PLAN COMMISSION AGENDA - ADDENDUM

PLAN COMMISSION REPORT

Proposal:	Plan Review – Single-Tenant Industrial Building (Warehouse and Offices)
Description:	Site, building, and related plan review for a proposed single-tenant warehouse facility with associated offices.
Applicant(s):	Matt Kohls, Global Schoolwear
Address(es):	200 W. Oakview Parkway (5 th Aldermanic District)
Suggested Motion:	Staff have concerns regarding the request as stated in the report below. Please refer to the report for decision options when considering the following motion.

Sheet:
SITE GRADING & EROSION CONTROL PLAN

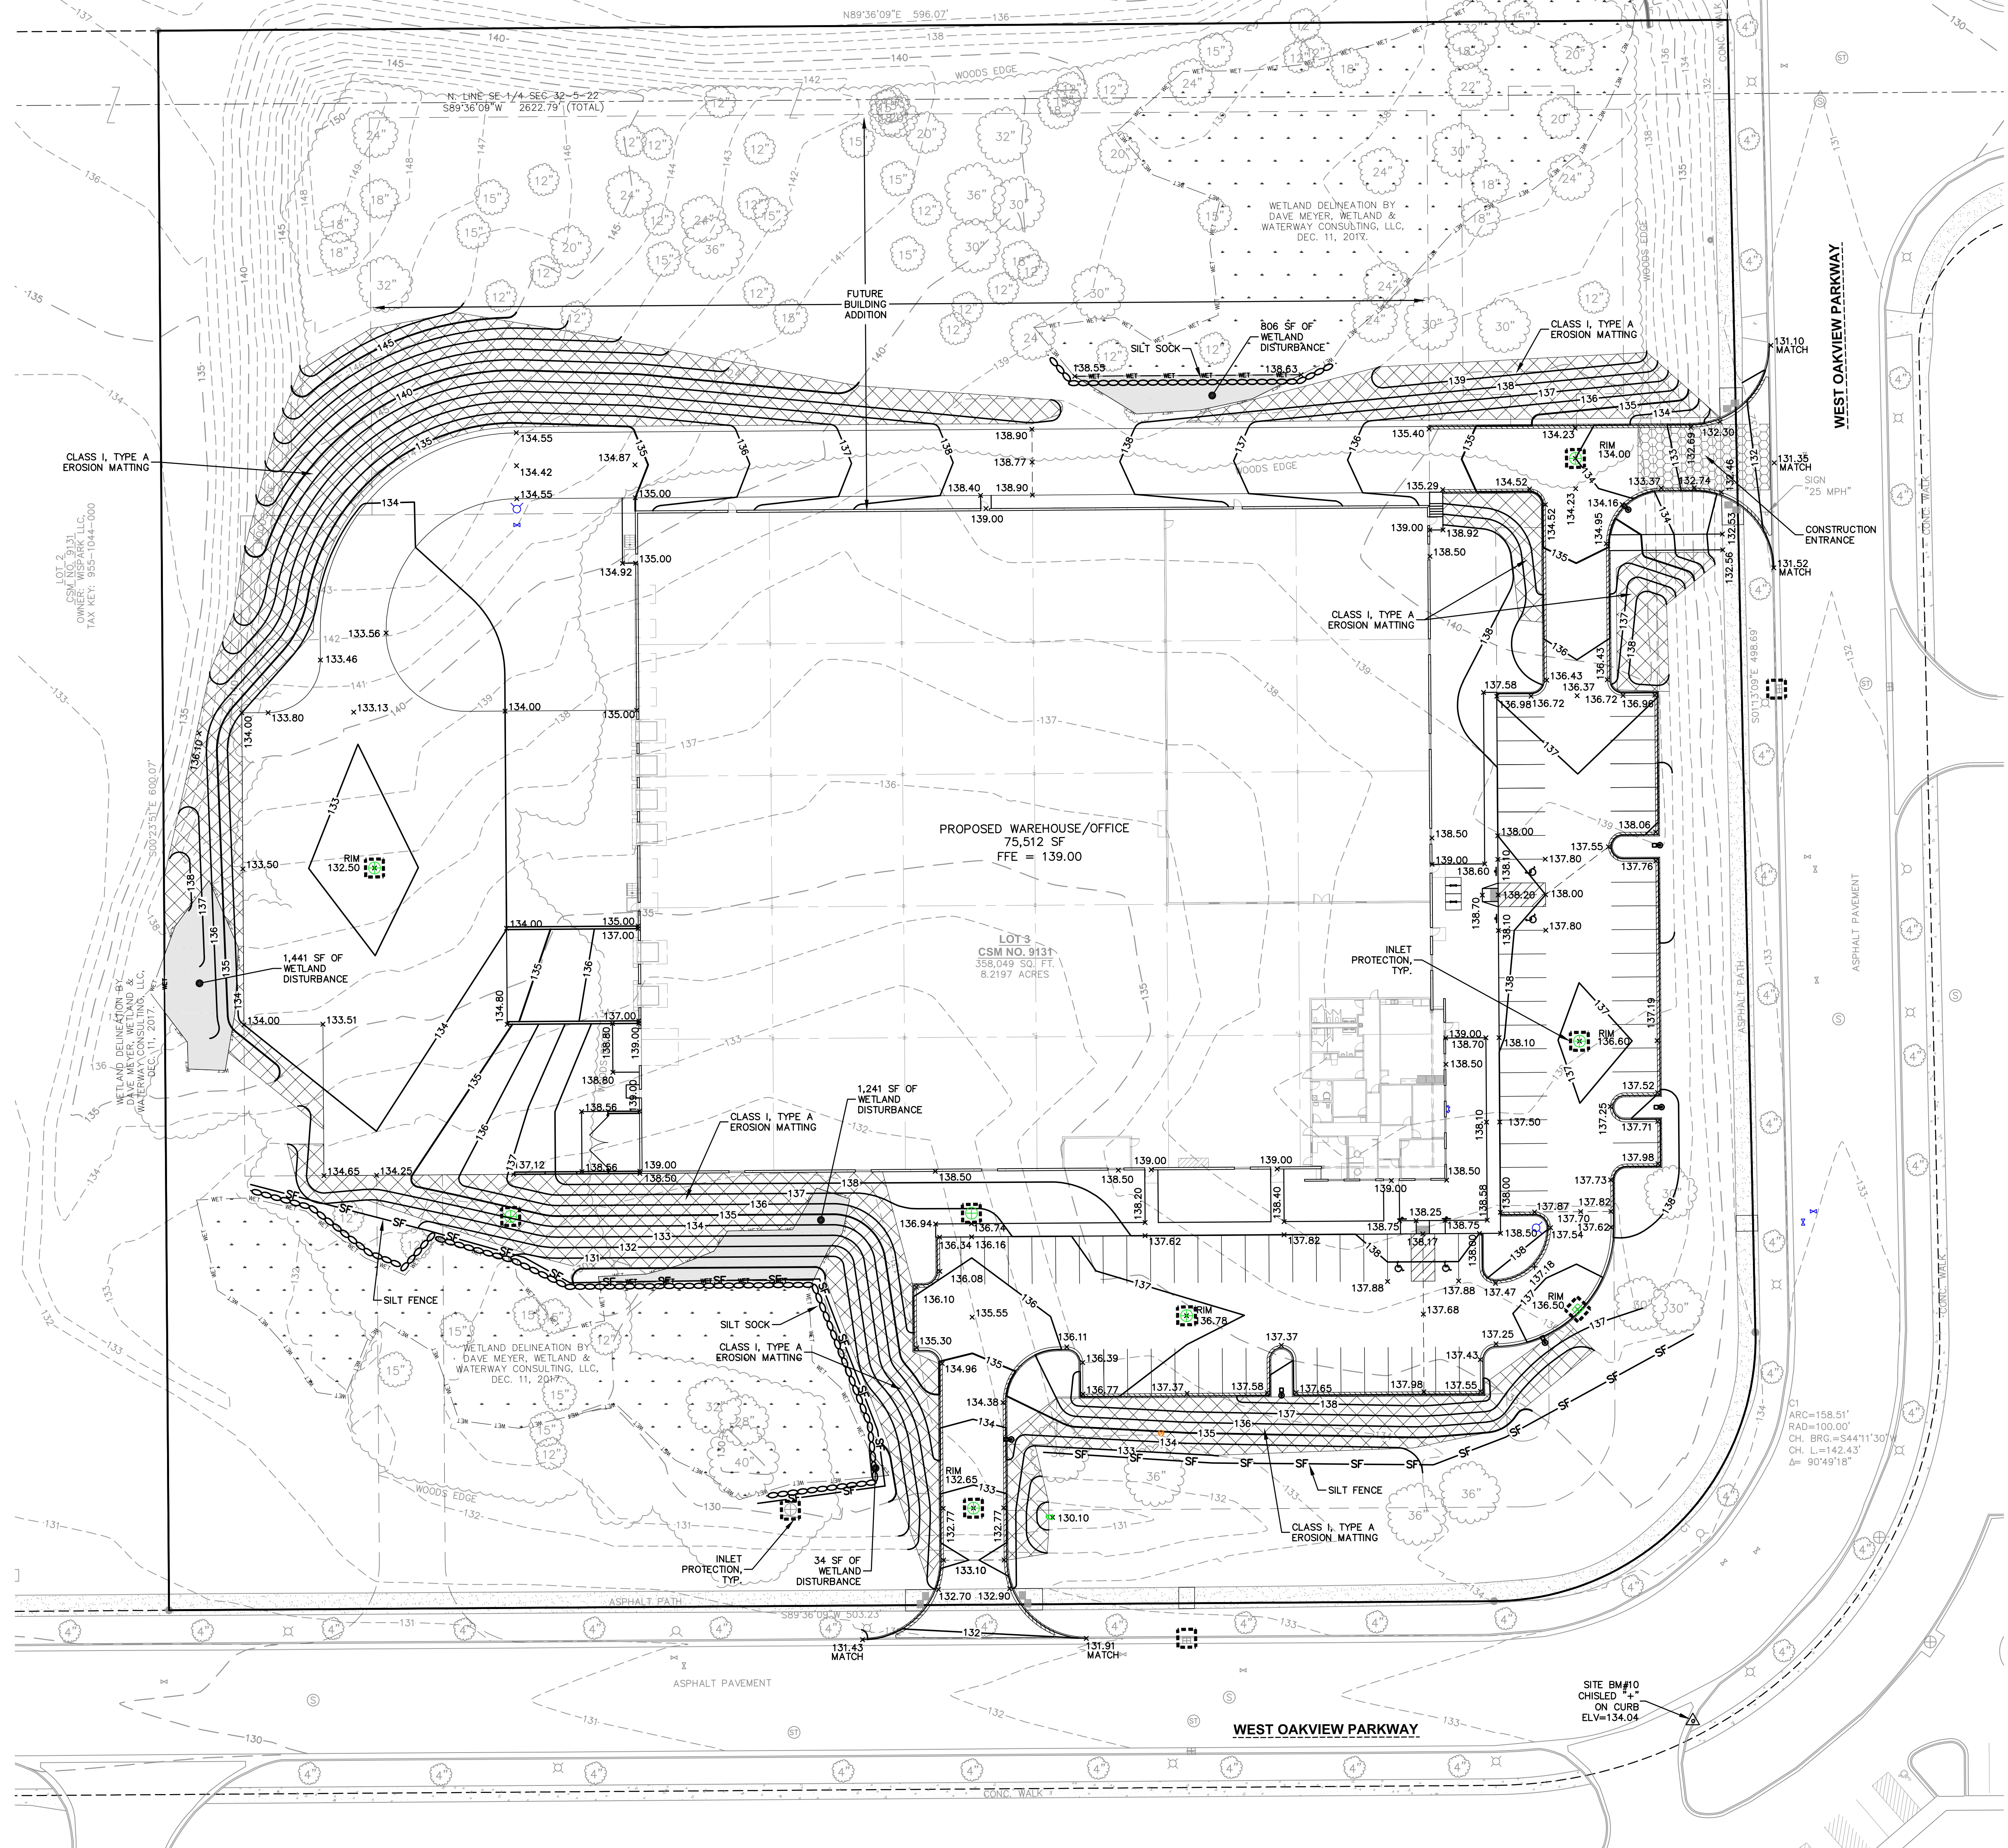
4). Clarify narrative statement: On page 1 of the submitted narrative, you state that *“There are also wetlands on the property and as part of the first phase of development they will not be disturbed.”*. Please clarify this statement, as elsewhere in the application you state that 3,522 square feet of wetland disturbance is required for the preferred alternative.

Sheet:
ELEVATIONS STREET
FACADE OPTION

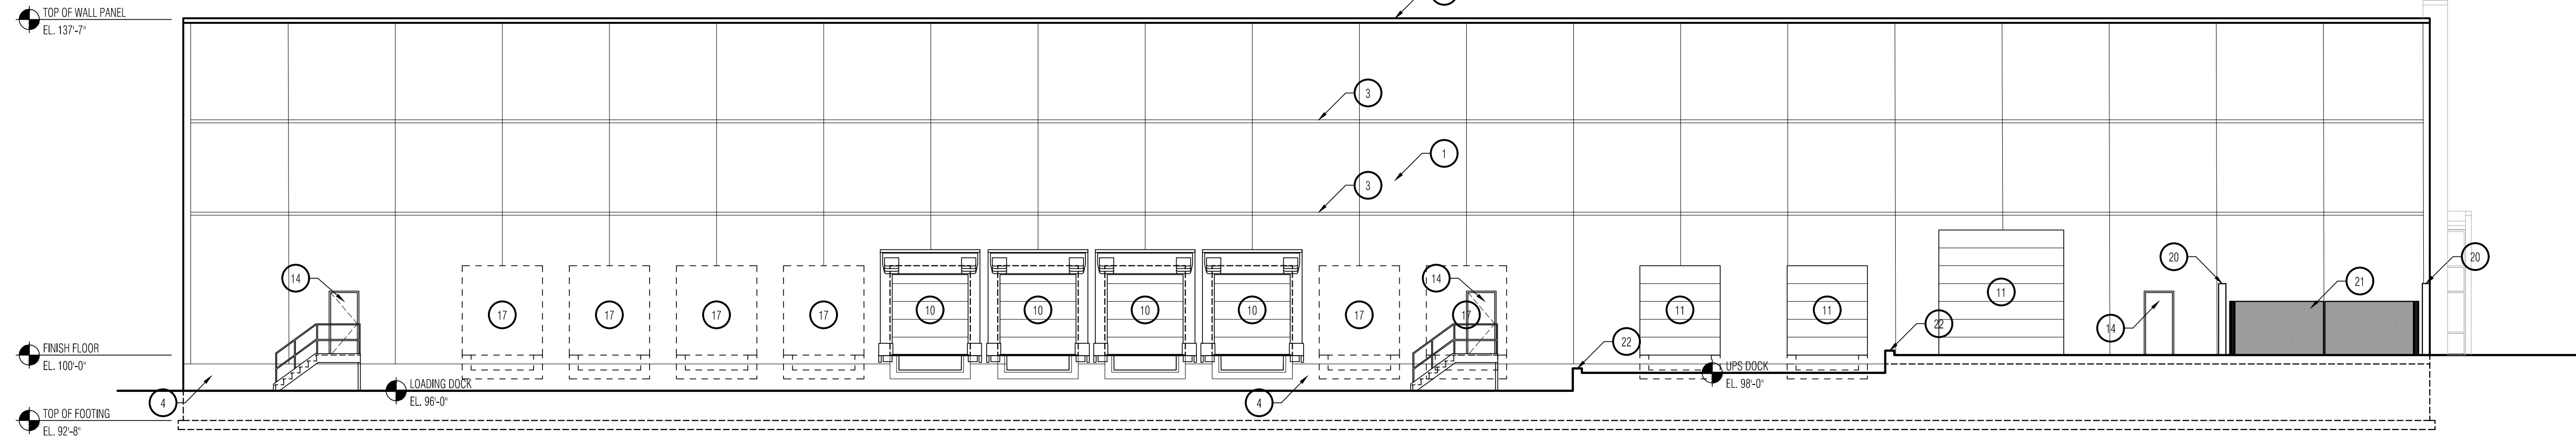
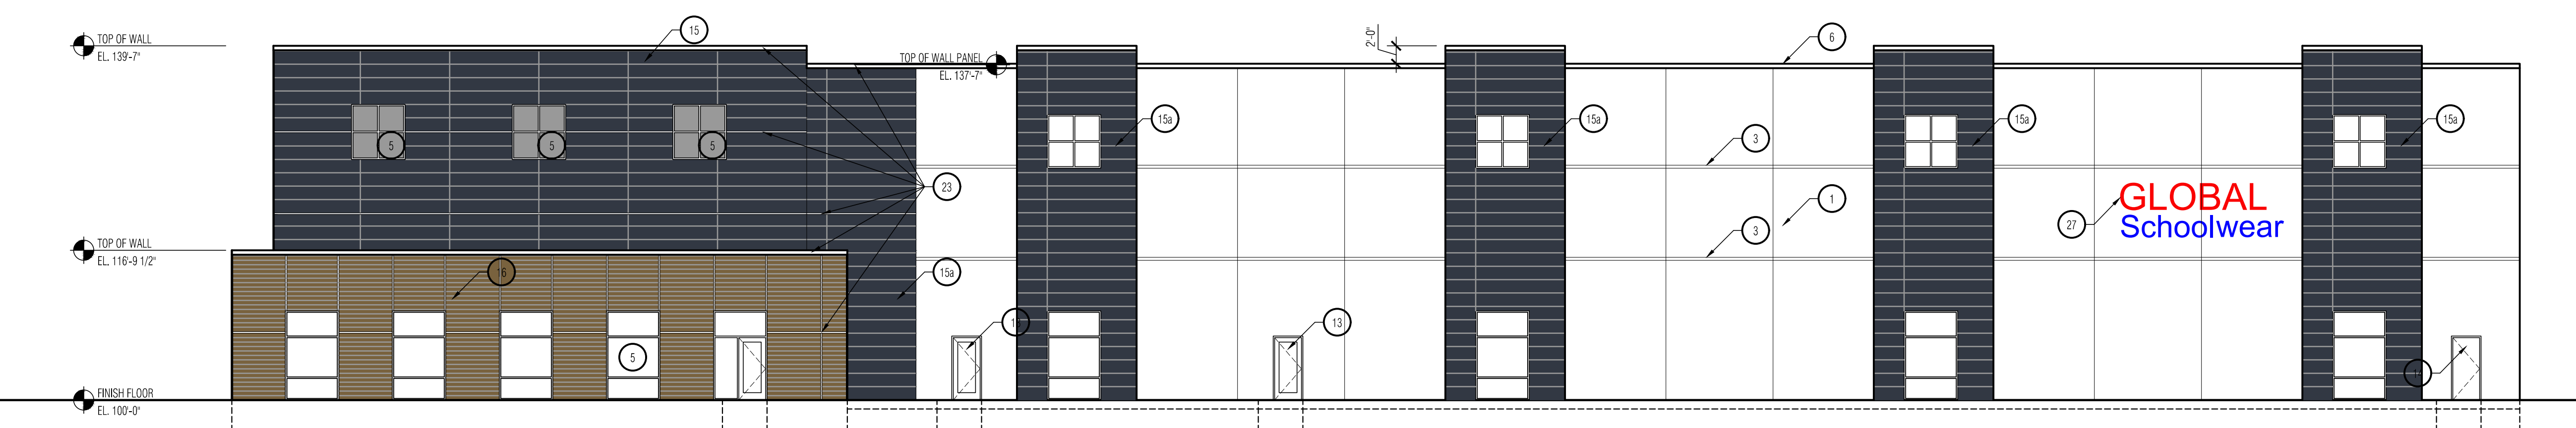
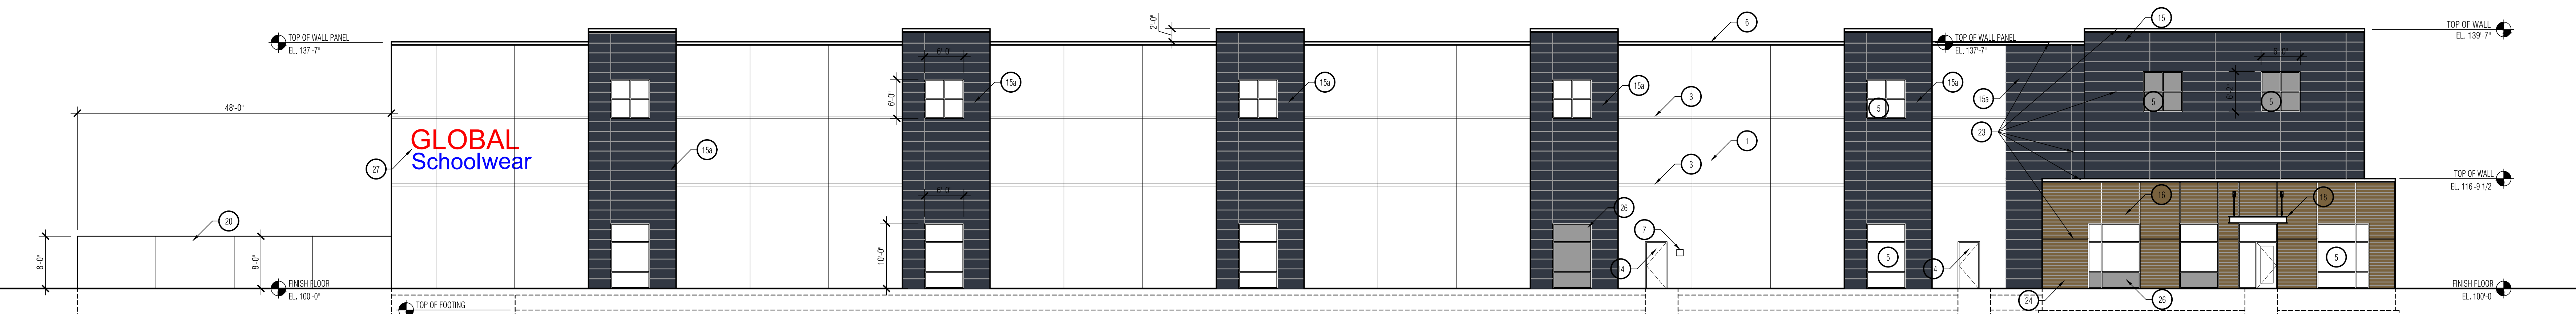
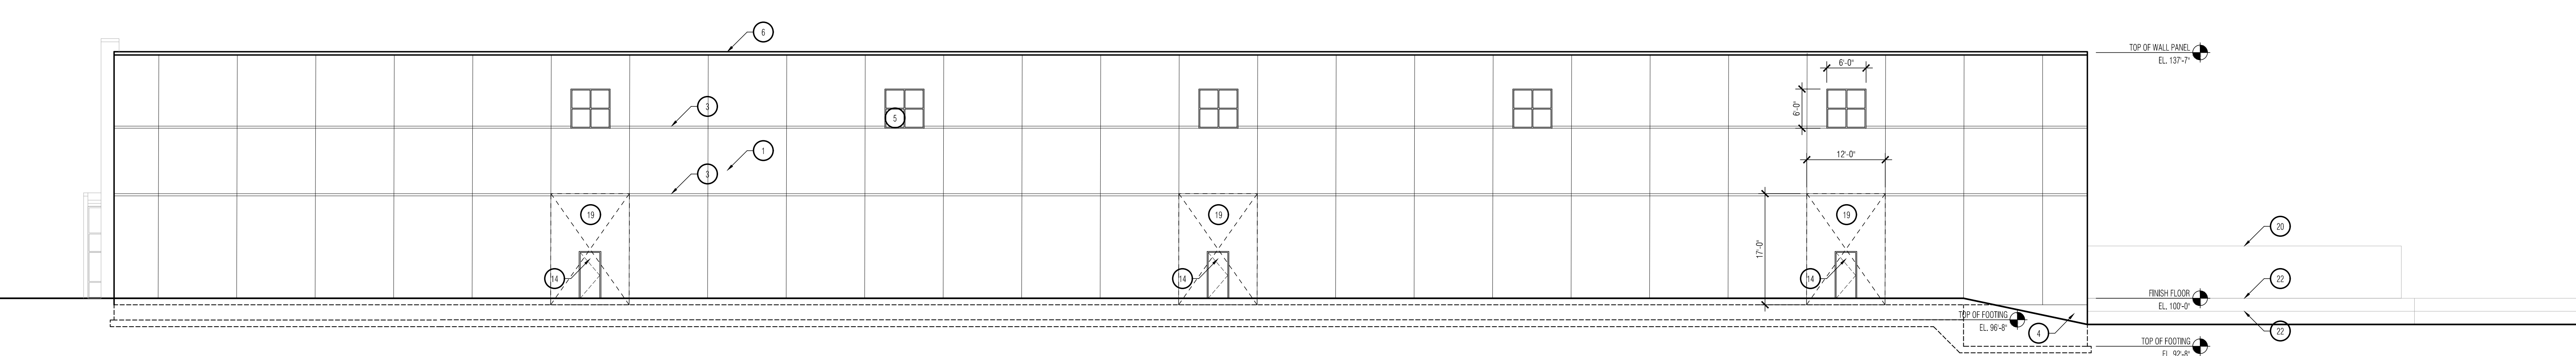
- 9. That the building elevations are revised to incorporate roofline variations and building materials and articulation in conformance with Code.
- 10. That all detailed, revised plans are submitted in digital format to the Department of Community Development prior to submission of permit applications.

Primary exterior building materials for the building are proposed to be painted, insulated, precast concrete wall panels (white and graphite accent on the east and south) for the warehouse, and Nichiha panels (graphite and cedar vintage wood) for the office portion. Windows are proposed on all but the west elevation, with a majority of the glazing elements on the southeast corner entries. While the office portion on the southeast corner of the building includes variations in the roof height and projections of the wall elements, the remaining building has a single roofline and no recesses or projections along the lengths of the warehouse walls. Per Code,

- Textured concrete is allowed at any percentage of any elevation; non-textured concrete is allowed up to a maximum of 50% of each elevation (Table 17.0511(a)(1)).

- A flat roof appearance is not permitted in mixed -use or non- residential zoning districts. Parapets, overhanging eaves, sloped roofs, or other roof form shall be incorporated into the design of the building (Sec. 17.0511(a)(5)).

- For facades and elevations facing or visible from a right-of-way and/or at least 100 feet in length
 - The frontage of the building shall be divided into architecturally distinct sections or bays with each section taller than it is wide.

- Sections or bays shall be visually established by architectural features such as columns, ribs, pilasters, piers, recesses, projections, windows, awnings, arcades, or an equivalent element that visually subdivides the wall with a roof or cap features that provides a rational terminus and integrates with the overall design of the facade. Windows, awnings, and arcades must be an integral part of the facade abutting a public street.

- The required dividing elements shall have a minimum width of one (1) foot and minimum projection to width ratio of 1:4.
 - Each principal building shall have a clearly defined, highly visible customer entrance with features such as canopies or porticos, arcades, arches, wing walls, and integral planters (Sec. 17.0511(b)(2)).

Staff have included a recommended condition of approval for the elevations to incorporate the requirements of Code above. Signs shown on the building are placeholders and not part of this review.
